May 12, 2006

**RE: APRIL 12, 2006 MEETING
WTC MEMORIAL AND MEMORIAL MUSEUM
PROJECT NOS. 7383-4 & 7966-4**

RE: FIRE SIMULATION STUDIES
WTC MEMORIAL AND MEMORIAL MUSEUM
PROJECT NOS. 7383-4 & 7966-4

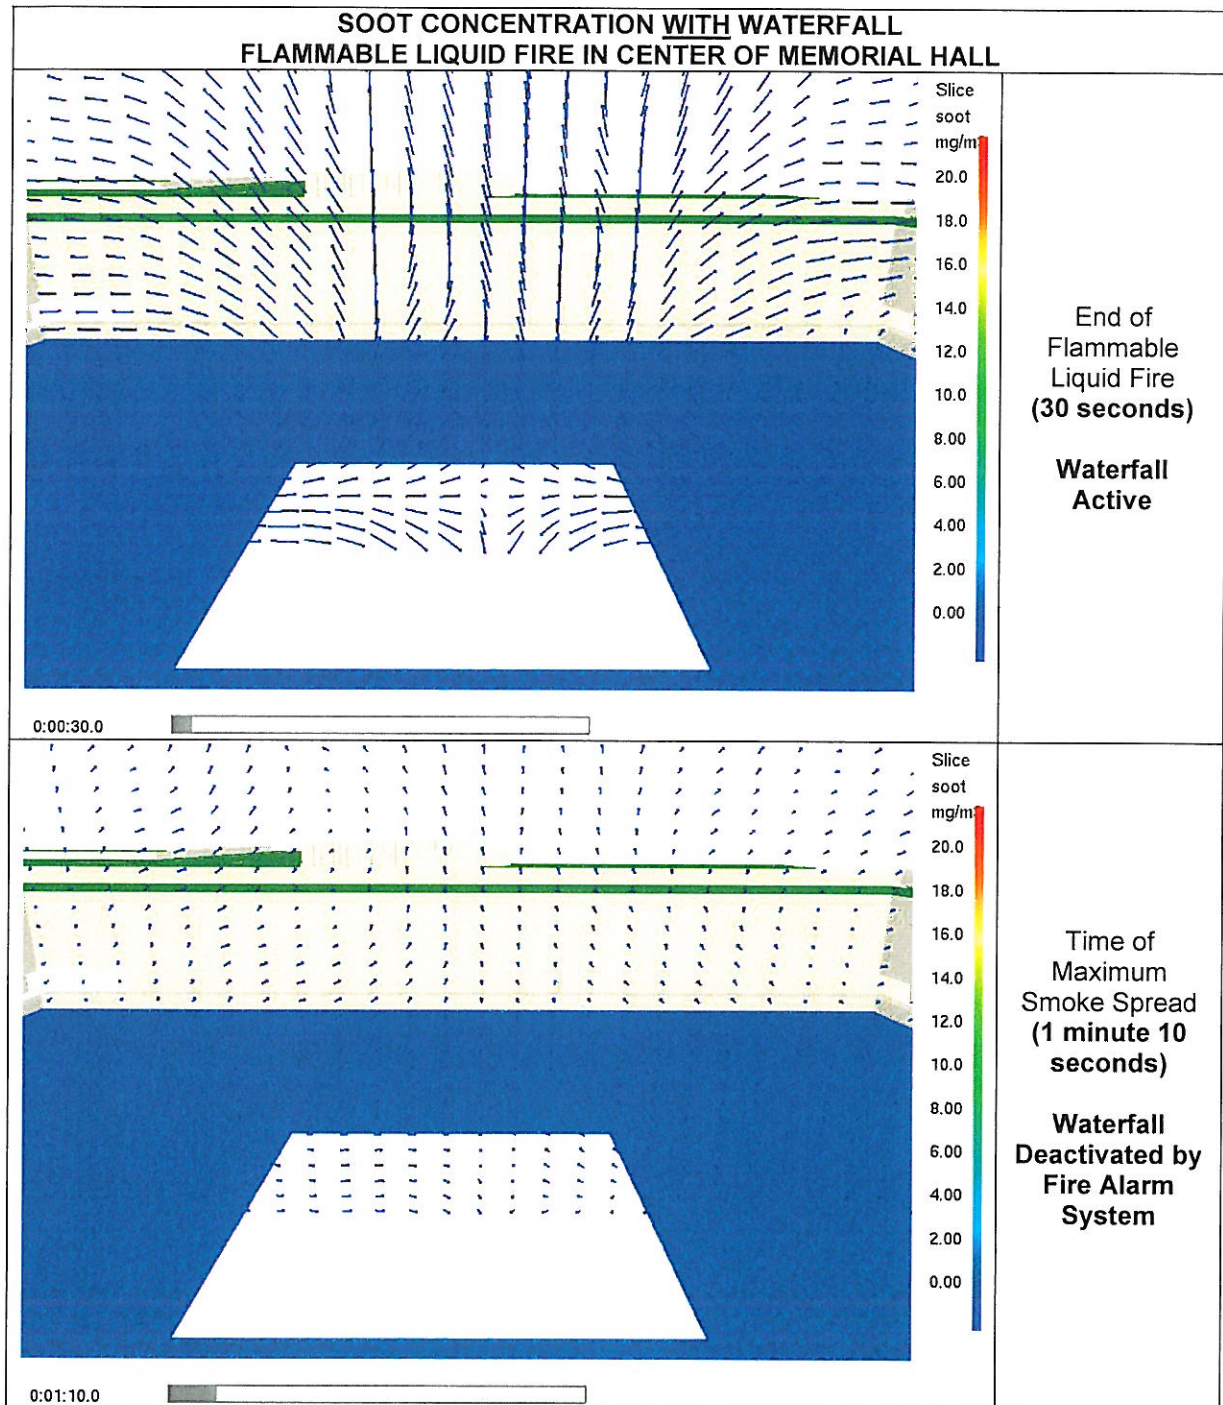
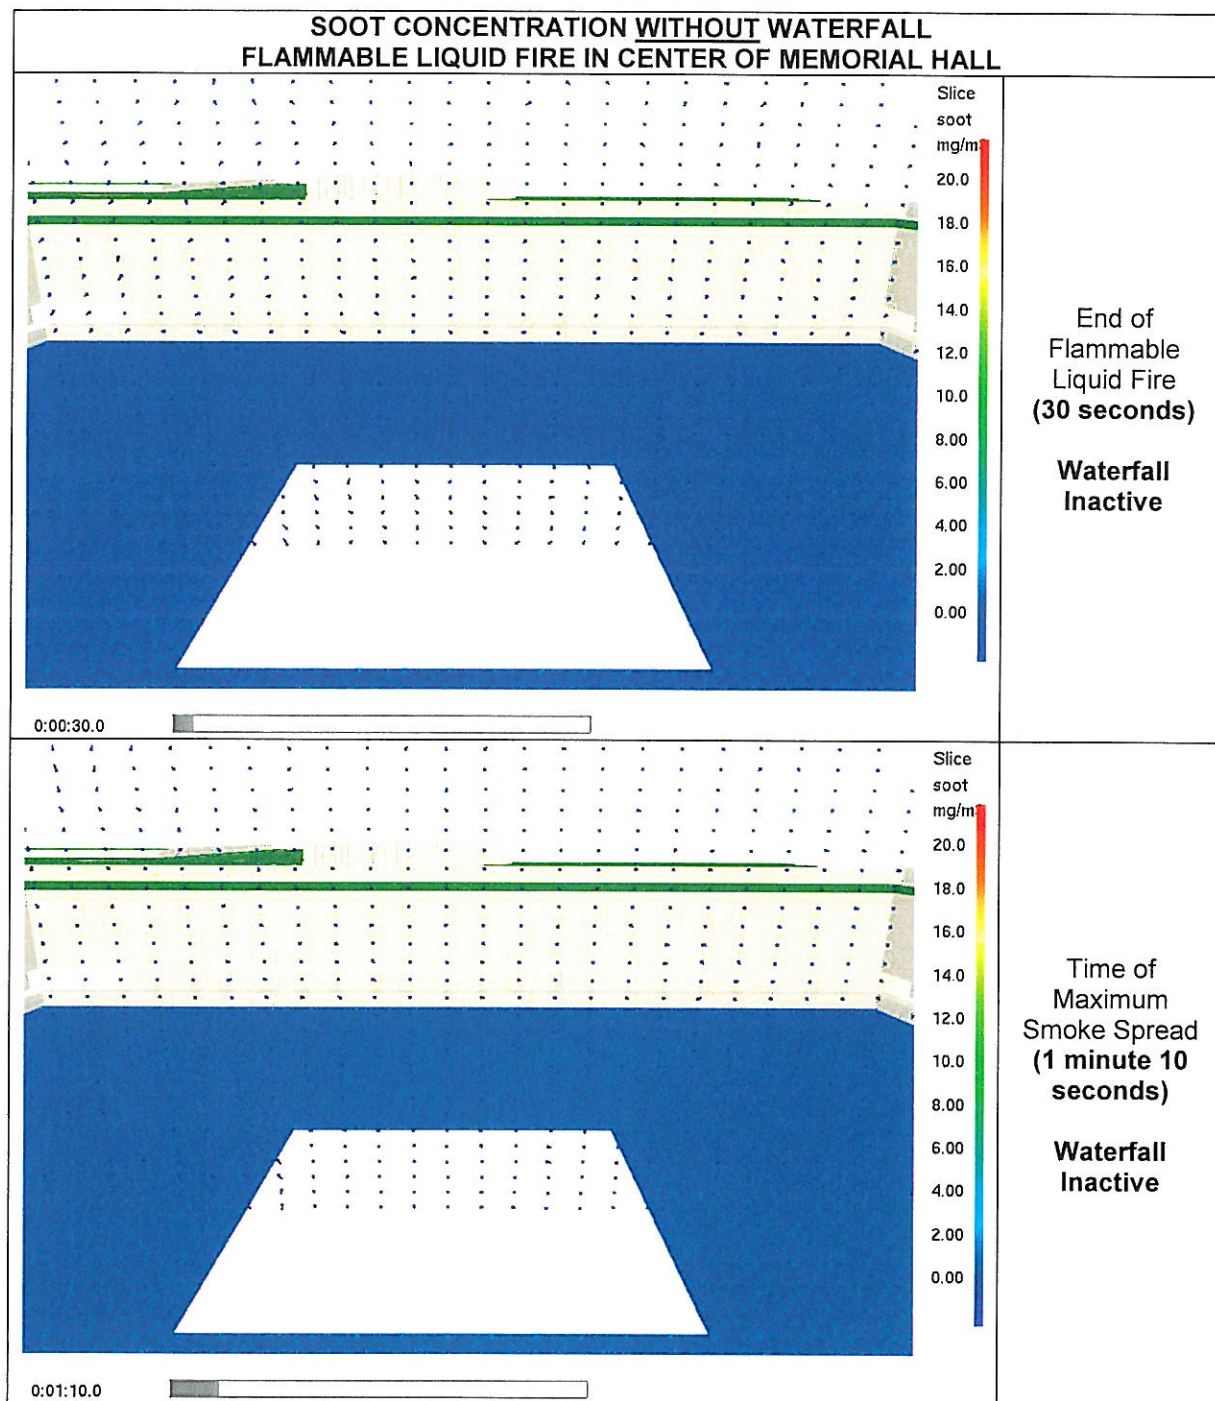
1. Responses to each of the questions in the email from Ms. Saakian dated March 31, 2006 were discussed. Responses are documented in the enclosed letters from CCI and Davis Brody Bond, LLP (DBB) dated April 12, 2006 (Enclosure A). Copies of the letters from CCI and DBB were provided to the FDNY at the meeting.
2. Mr. Subbarao requested that data be submitted indicating the concentration of soot in the air that travels through the openings at the center of the Memorial pools during the Memorial Hall fire and indicating the time at which the concentrations were measured. CCI noted that the air traveling through the openings is fresh air drawn from above the Memorial, which is not expected to carry any smoke particles.

The following tables illustrate the concentration of soot in the air flowing through the opening in the center of the reflecting pool during a 30 MW flammable liquid fire in the Memorial Hall, with and without the effects of the waterfall.

The figures show a section through Memorial pools, with the airflow indicated using velocity vectors. The snapshots are taken at the end of the flammable liquid fire (30 seconds) and at the time of

maximum smoke spread (1 minute 10 seconds). In the following figures, the velocity vectors are shaded to indicate the concentration of the soot in the air, with blue indicating no soot.

The figures above show that the air flow entering the levels below +284'-0" is induced by the waterfall, the effects of which were included in the CFD model for the Memorial. After the waterfall shuts off, the air flow entering the levels below +284'-0" is minimal. As demonstrated in the figures above, the soot concentration of the air traveling through the opening is near zero. This indicates that smoke is not traveling to the floors below. The Fire Dynamics Simulator (FDS) input files for simulations of a flammable liquid fire in the Memorial Hall with and without the waterfall are included on the enclosed CD-ROM.

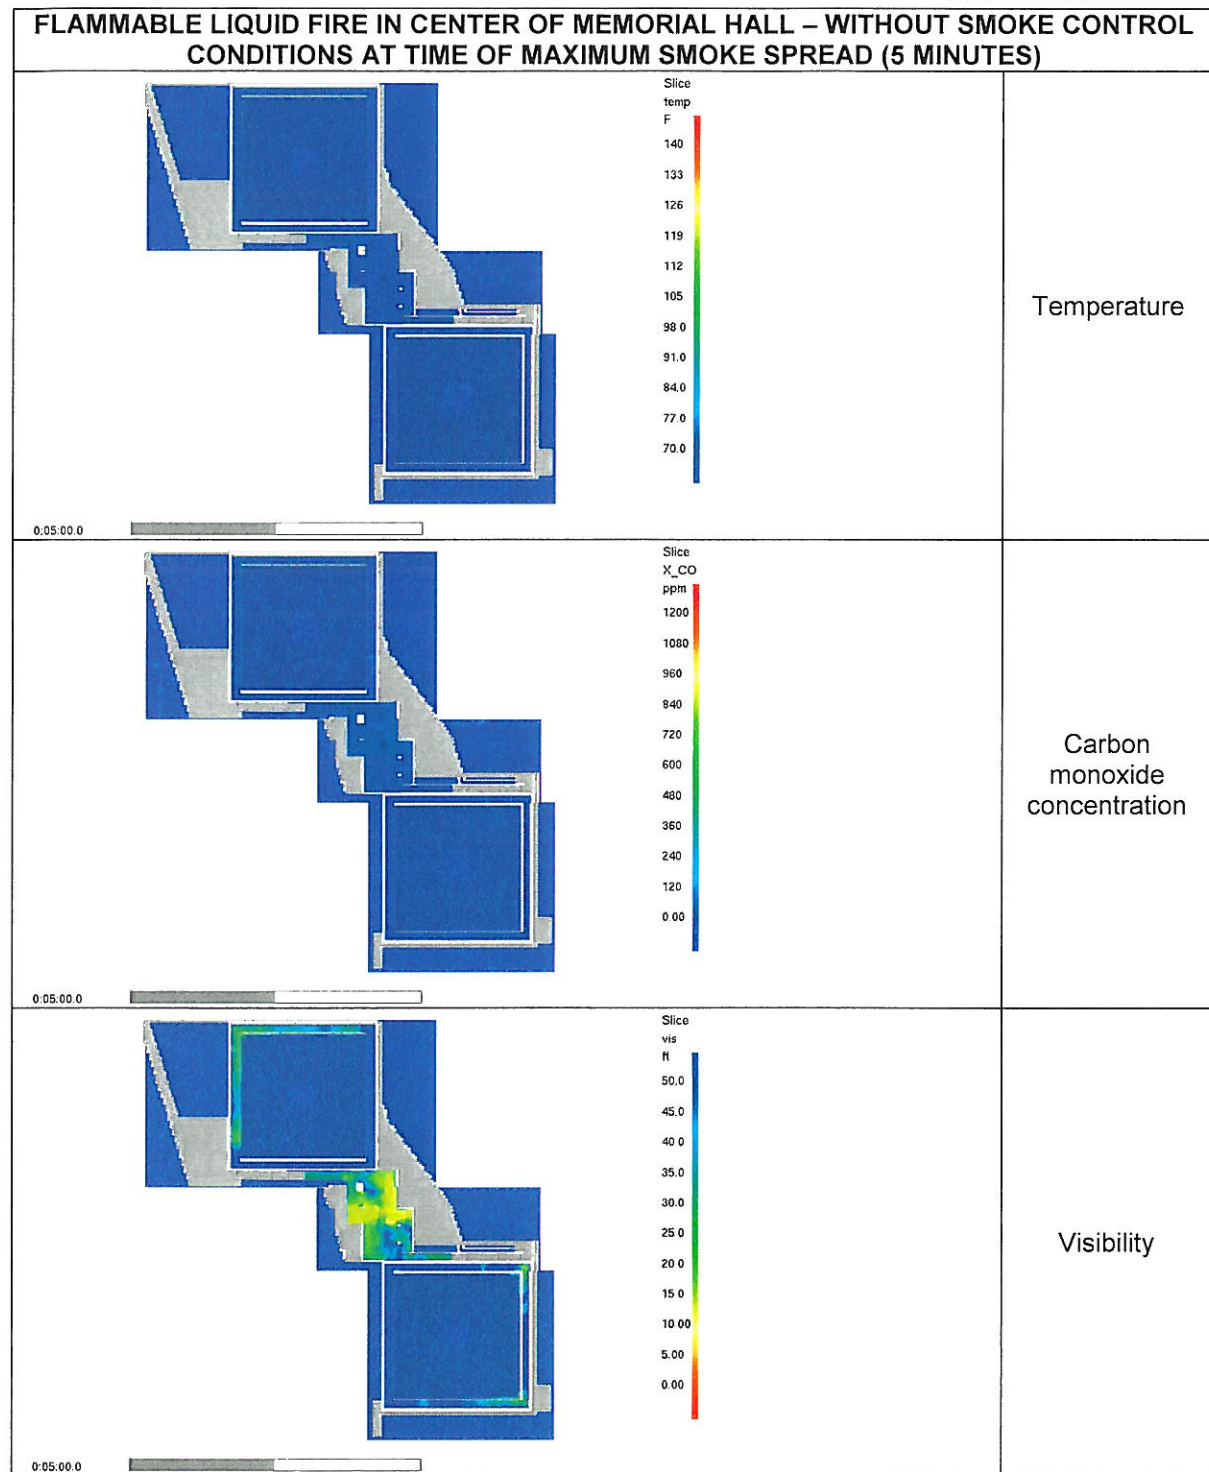
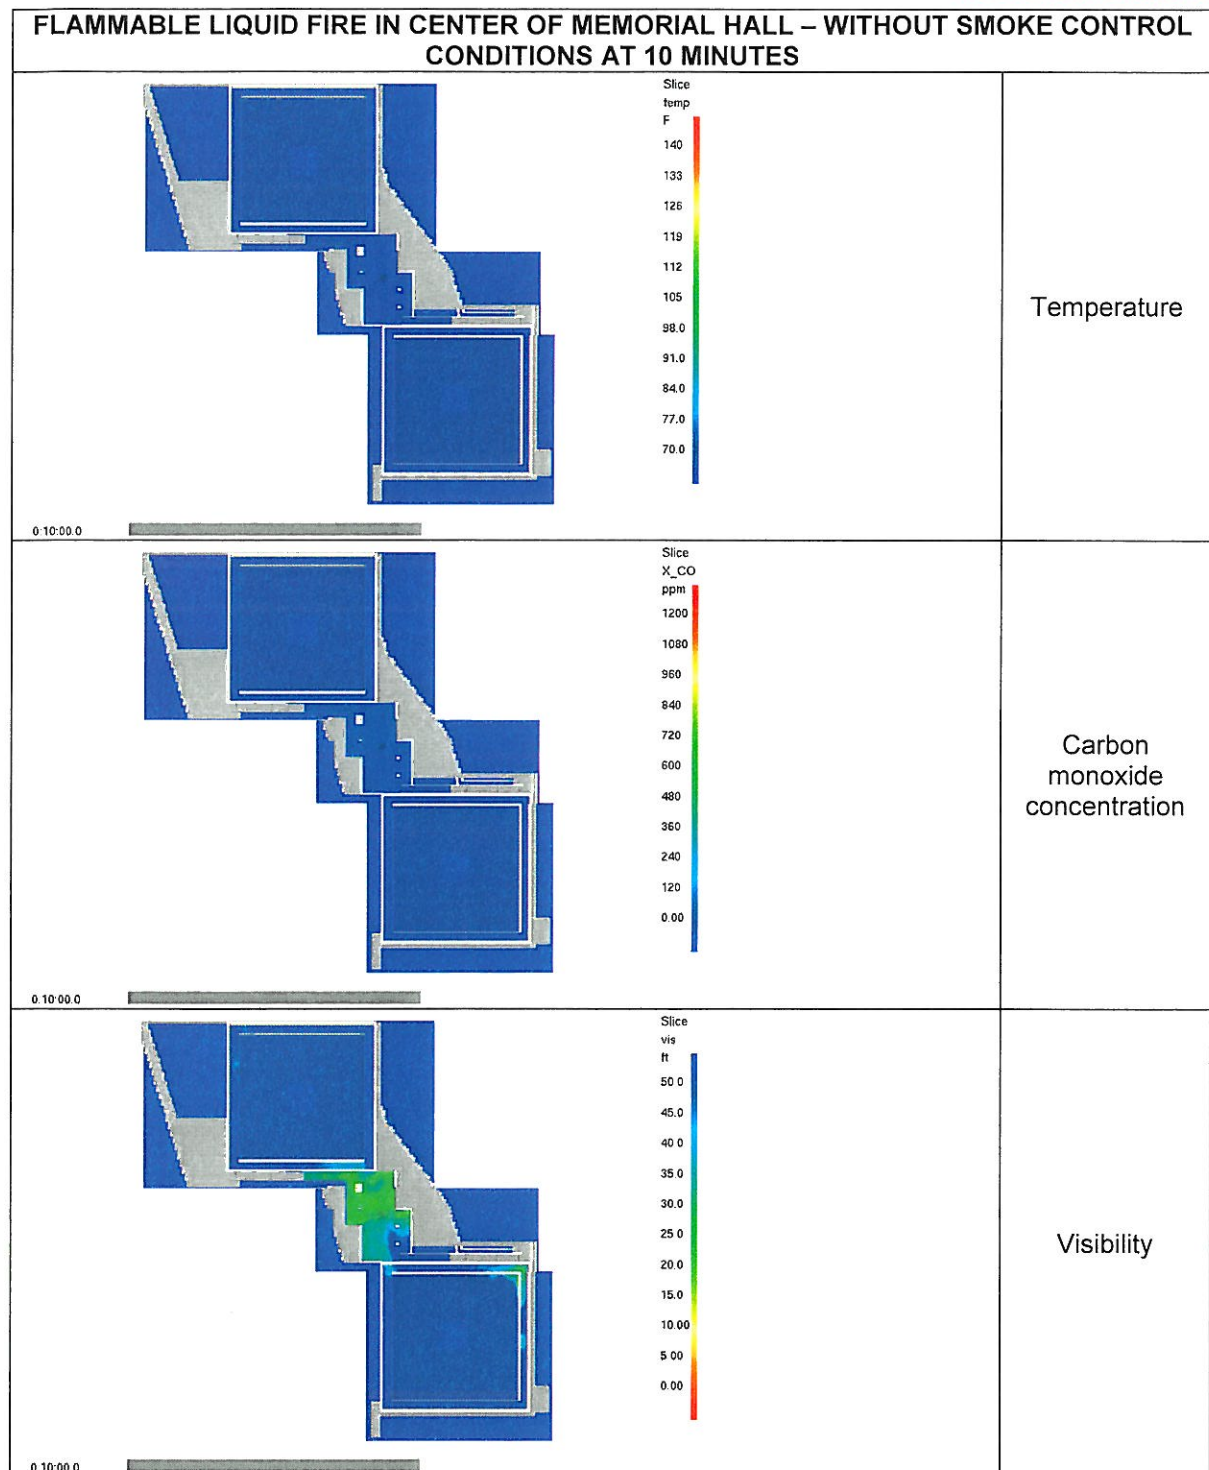
8. The FDS input file for the flammable liquid fire in the Memorial Hall was reviewed. Exhaust vents were identified in the input file and the corresponding vents were located in the Smokeview rendering.
9. Mr. Subbarao requested that results be submitted for a flammable liquid fire in the Memorial Hall with the smoke control system inactive.

The results requested are provided below. The FDS input file for this scenario is provided on the attached CD-ROM.

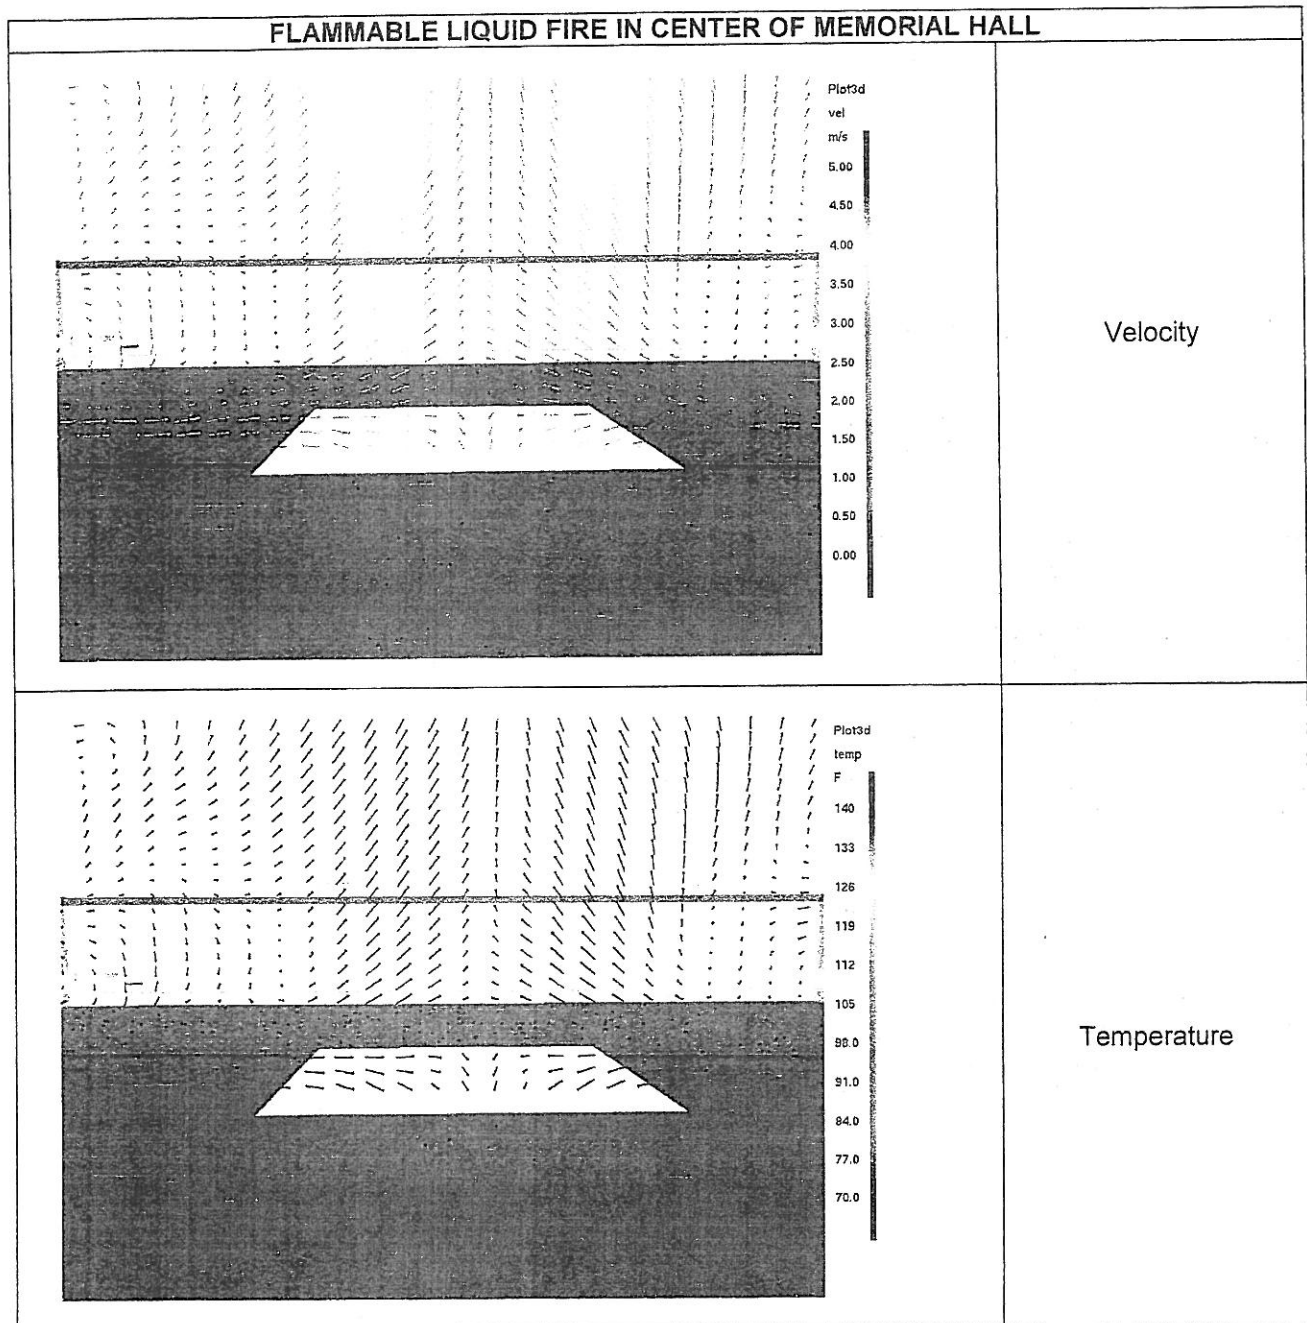
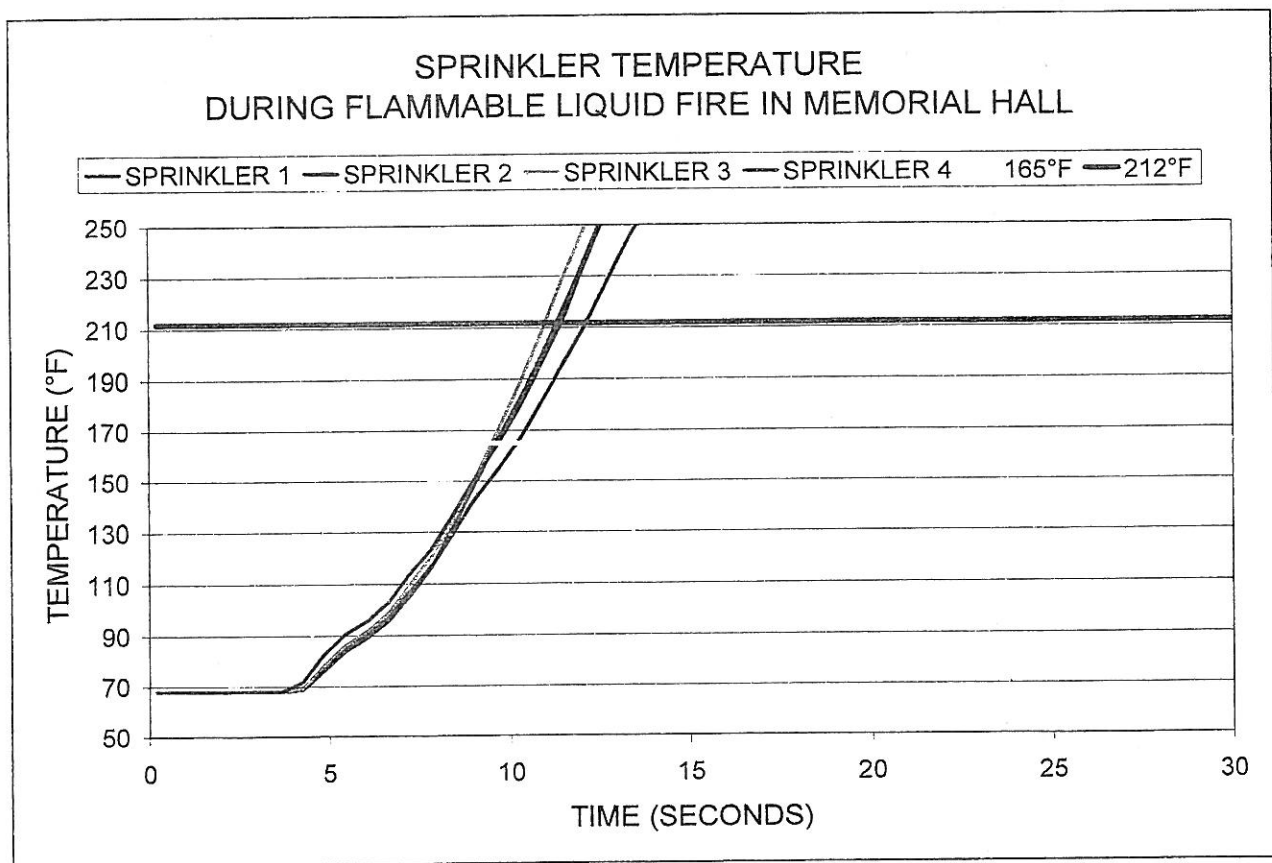
4. *Provide information of tenable condition parameters such as heat and smoke density for the slice where air is drawn into floors below +284.*

The following table illustrates the air flow into the floors below the +284'-0" level during a flammable liquid fire in Memorial Hall. The figures show a section of the Memorial pools, where airflow is indicated using velocity vectors. In the first figure, the velocity vectors are shaded to indicate the velocity of the flow. In the second figure the velocity vectors are shaded to indicate the temperature of the air.

The air flow entering the levels below +284'-0" is induced by the waterfall, the effects of which were included in the CFD model for the Memorial. Thus, the air entering the level below +284'-0" is fresh, outside air. Note that the temperature of the air passing into the opening is at ambient temperature (70°F) indicating that smoke or products of combustion are not present.
